ADDENDUM #04

Greene County Visitor Center Project
705 Main Street, County Road 23B, Leeds, N.Y. 12451
Kaaterskill Associates Project No.: 84517.06

Addendum 04 Issue Date: May 29, 2024

1 ELECTRICAL SITE PLAN
1" = 10'-0"

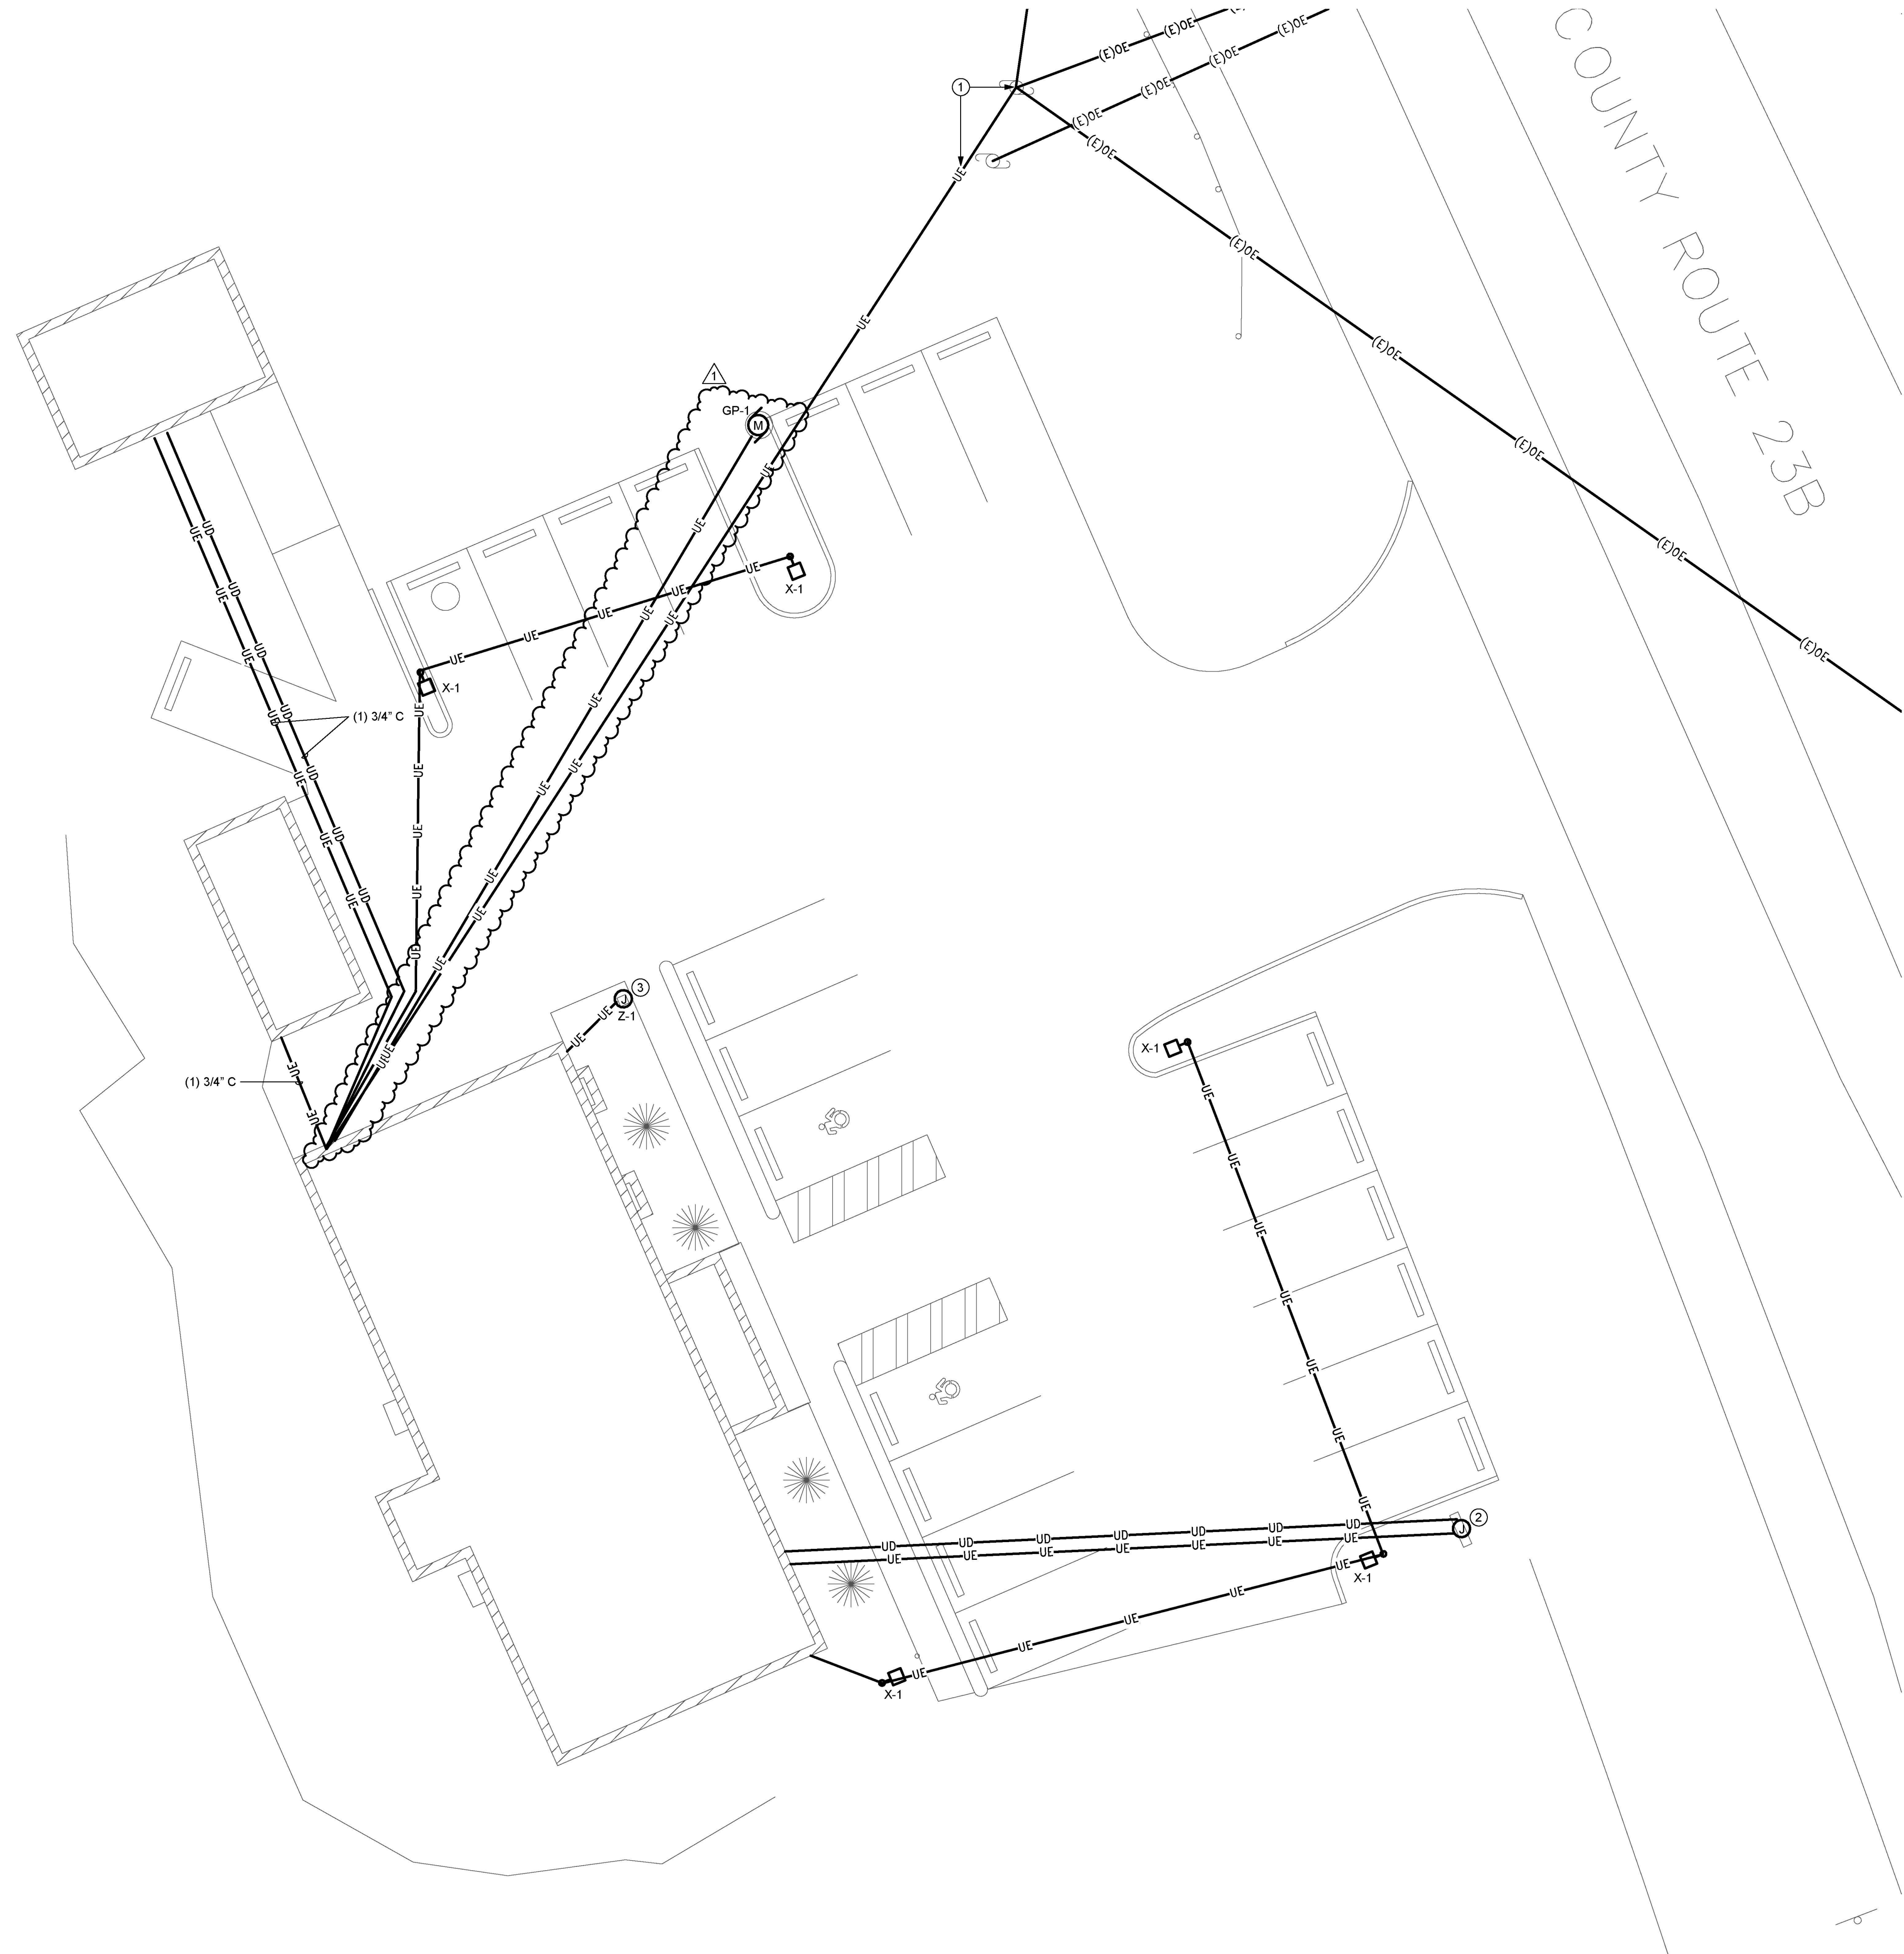
<u>Sheet/Detail</u>	<u>Description</u>
E-3	Added to current Bid Set: (see revision clouds)
E-6	Added to current Bid Set: (see revision clouds)
E-7	Added to current Bid Set: (see revision clouds)

Q031: There is no branch circuit shown on the Panel Schedule for the Pump Station.

A031: Refer to revised Electrical drawings E-1 through E-7, revision date 05/28/24.
